SECTION 96(2) MODIFICATION APPLICATION ASSESSMENT REPORT

**TOURIST FACILITY
40 DOGWOOD ROAD, BUNGWAHL**

DA 173-7-2004 MOD 1

Figure 2 - Stage 1 modifications. Originally approved building envelopes are outlined in red.

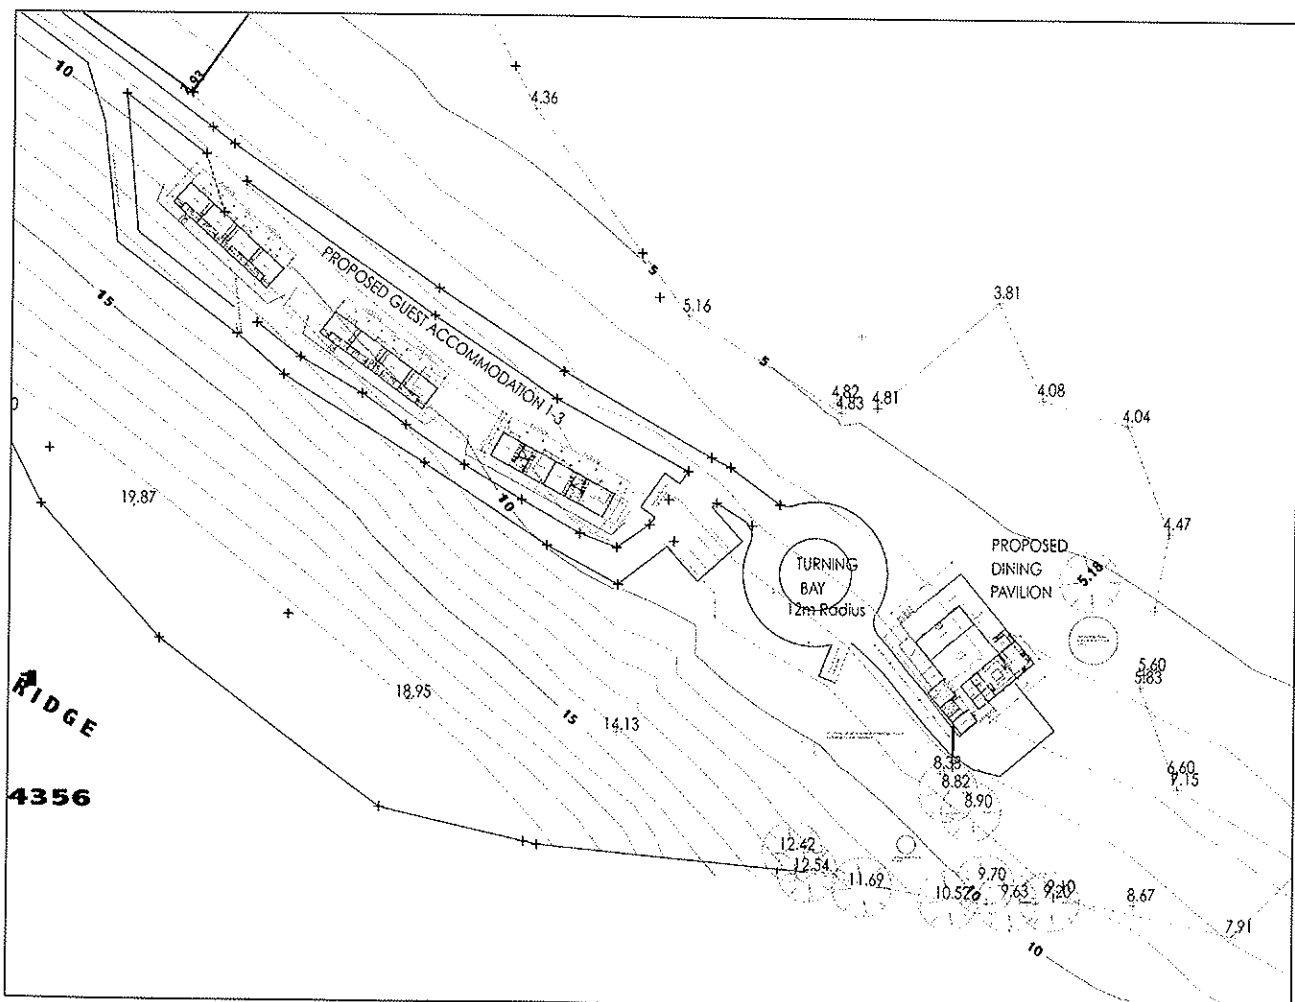
- The applicant seeks to modify Stage 1 of the consent. The proposed changes involve the redesign of the accommodation buildings to include an ensuite for each unit which removes the need for a separate amenities block. The three bunk houses (containing 3 bunk rooms each) are to be replaced with 3 long houses, each containing 4 separate, ensuite units. The proposal involves an increase to the approved building footprint of the accommodation buildings (refer Table 1 below) but retains their approximately approved location and alignment on the site (refer Figure 2 above).

- The proposal also involves changes to the dining pavilion - originally a roofed, open-air pavilion providing basic kitchen facilities in keeping with the 'camp site' character. In particular, the proposal provides for the incorporation of a lounge, a small reception area, toilets, and verandas to the north-east and north-west. The proposed changes will result in the self-catering kitchen area being more enclosed than originally approved, which is in keeping with the provision of higher quality, more comfortable accommodation and facilities the new owner seeks.

- The proposal involves an increase in the footprint the dining pavilion occupies (refer to Table 2), but also proposes to delete the approved amenities block from the rear of the approved open-air dining pavilion, and provide for amenities within each accommodation unit. The proposed dining pavilion is situated in approximately the same location as where the original open-air dining pavilion was approved (refer Figure 2).

- The building footprint of each long house accommodation cabin will occupy a larger area than the originally approved bunk houses. However the inclusion of ensuite facilities in these cabins that removes the need for the amenities block which was approved up the slope at the rear of the site. The location and alignment of these buildings remains approximately the same as approved.

- While the modification application proposes an increase in building footprint of the dining pavilion, it is expected that there will be no additional adverse environmental effects than those consented to. The redesign of the dining pavilion allows for a larger enclosed area, allowing for greater use of indoor space throughout the year, and potentially a further reduction in ambient noise levels. Asset Protection Zones for bushfire safety are discussed in section 5.3 below.

- 3) Replace condition A1(1)(a) with the following:

- (a) Construction of three (3) ensuite accommodation buildings, each with four (4) units.

- 4) Delete condition A(1)(c) as the amenities block is no longer part of the proposal.

Figure 3 – Site plan

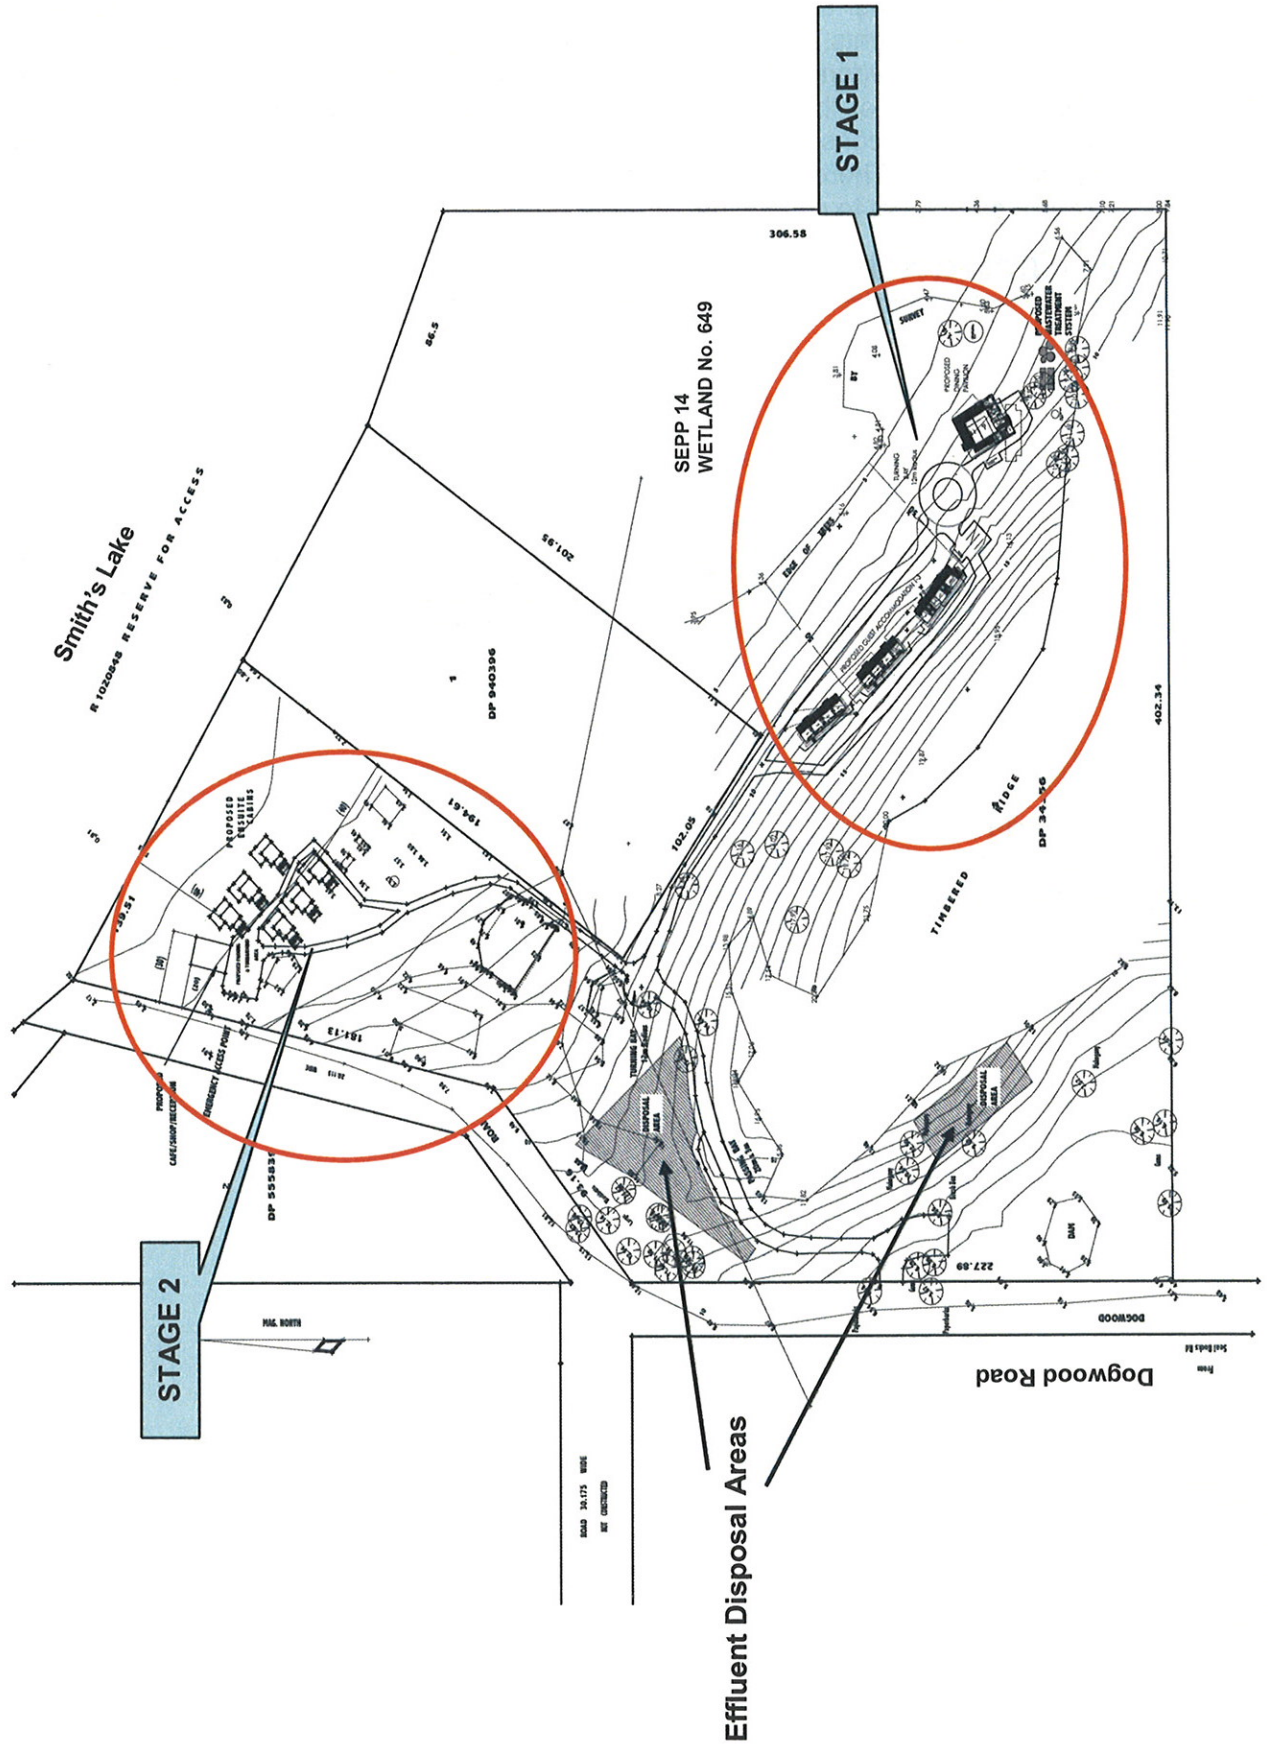
- The location of proposed effluent disposal areas is shown on Figure 3 below. These indicative effluent disposal areas are sufficiently far removed from the environmentally sensitive areas of the SEPP 14 wetland and Smith's Lake foreshore to ensure that potential for any adverse effects is minimised. Thus the proposed location of effluent disposal is consistent with the intention of the originally approved location, and therefore the proposed wastewater treatment system design satisfactorily addresses concerns raised by both the NSW Office of Water and Great Lakes Council about potential impacts of the system on the adjacent SEPP 14 wetland. Furthermore Council retains final approval of the effluent disposal system to further ensure there are no additional environmental effects from the on-site treatment and disposal of wastewater.

The proposed effluent disposal systems are to be designed, selected and located in accordance with the on-site effluent report prepared by Aquatech Treatment Systems, entitled "*On-site Effluent Disposal Investigation Report at Lot 1 DP 34356, 40 Dogwood Road, Bungwahl, NSW*" and dated February 2010, and further information from Aquatech Treatment Systems dated 5 June 2010. Details shall be submitted to and approved by Council prior to the issue of a Construction Certificate.
